# Access Compliance Report

## Public Rights-of-Way

### (Curb Ramps)

Intersection ID: 30194	Main Street: HIDDEN_CREEK_DR	Cross Street: TANSY_DR	Location:	E
ADA ID: 19D6F65C71A8	Ramp Type: PerpDiag	Initial Pass/Fail: Fail	Overall Compliance: No	Severity Score: 12.5
Codes/Mitigation Info/Possible Solution		Field Measurements/Component Compliance

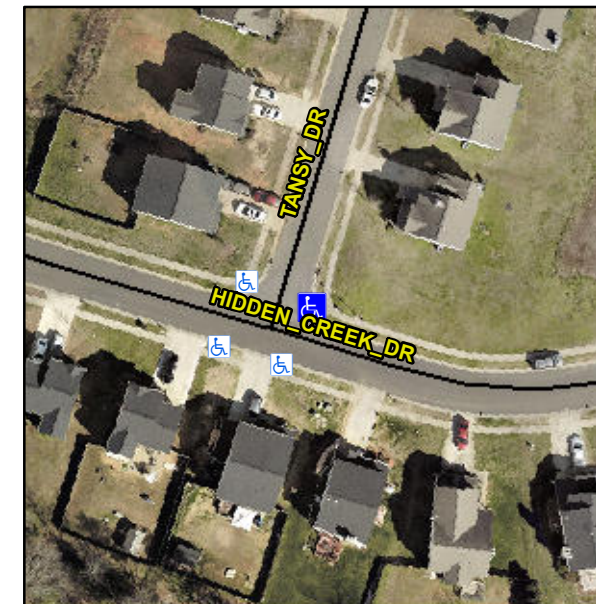
**Not Found, R304.2.2**

Compliance	Description	Data	Compliance	Description	Data
N/A	Ramp Length (in)	48.5	No	Ramp Slope (%)	8.7
Yes	Ramp Width (in)	48.0	Yes	Ramp XSlope (%)	1.1
N/A	Flare Type LT	N/A	N/A	Flare Type RT	N/A
N/A	Flare Slope LT (%)	N/A	N/A	Flare Slope RT (%)	N/A
N/A	Flare Traversable LT?	N/A	N/A	Flare Traversable RT?	N/A
N/A	Landing Length (in)	N/A	N/A	DWS Provided?	N/A
N/A	Landing Width (in)	N/A	N/A	DWS Contrast?	N/A
N/A	Landing Slope (%)	N/A	N/A	DWS Length (in)	N/A
N/A	Landing X Slope (%)	N/A	N/A	DWS Full Width?	N/A
N/A	Landing Curb? (Y/N)	N/A	N/A	DWS Offset (in)	N/A
N/A	Shared Landing?	N/A			
N/A	Gutter Ponding?	N/A	N/A	Gutter Slope (%)	N/A
N/A	Gutter Lip Ht (in)	N/A	N/A	Gutter X Slope (%)	N/A
N/A	Painted X Walk1?	No	N/A	Painted X Walk2?	No
	X Walk 1 Direction	To NW		X Walk 2 Direction	To SW
N/A	X Walk 1 Width (in)	N/A	N/A	X Walk 2 Width (in)	N/A
	X Walk 1 Slope (%)	2.5		X Walk 2 Slope (%)	2.5
	X Walk 1 X Slope (%)	0.7		X Walk 2 X Slope (%)	1.1

**Remove & Replace Curb Ramp With Two New Directional Ramps or Equivalent.**
